SB Number:	SB DP-002	Creation Date: 09/10/2004
Subject:	Work improvements (PAD change)	
Model:	DP-410

DP-410: Document Processor for KM-1620/2020, KM-1650/2050/2550

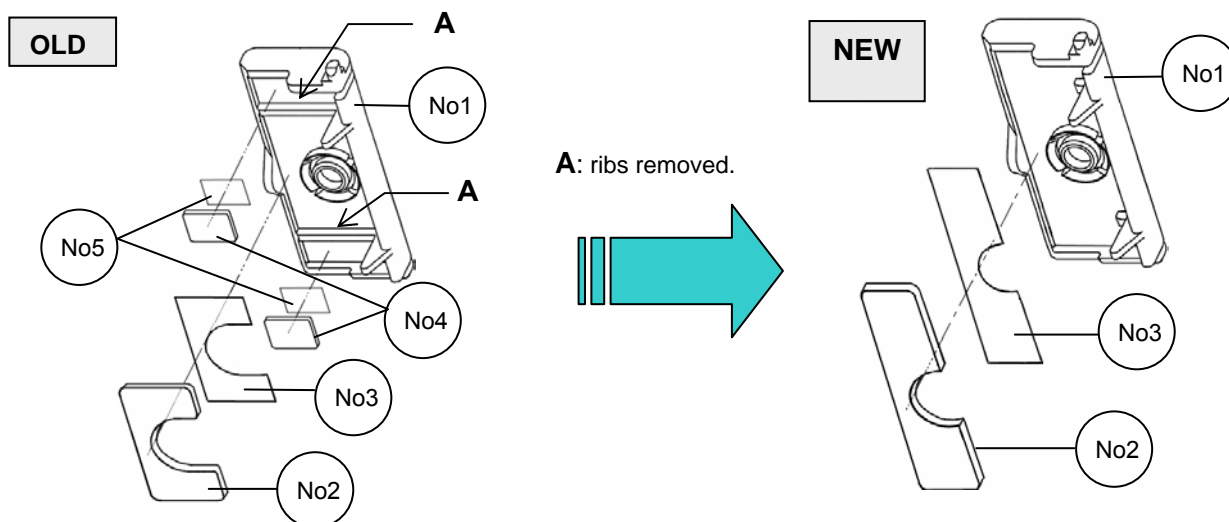
- The shape of the '**WEIGHT PAD**' (No.2) and '**TAPE WEIGHT**' (No.3) has been changed. In compliance with this shape change, the '**SUB WEIGHT PAD**' (No.4) and '**TAPE WEIGHT B**' (No.5) were discontinued.
- Two ribs on the '**HOLDER SEPARATION**' (No.1) have been removed (in compliance with above changes).

When the new parts should need to be attached to a machine that has not undergone these work efficiency changes, then please mind to replace new part No.1 to No.3 at the same time (see parts table).
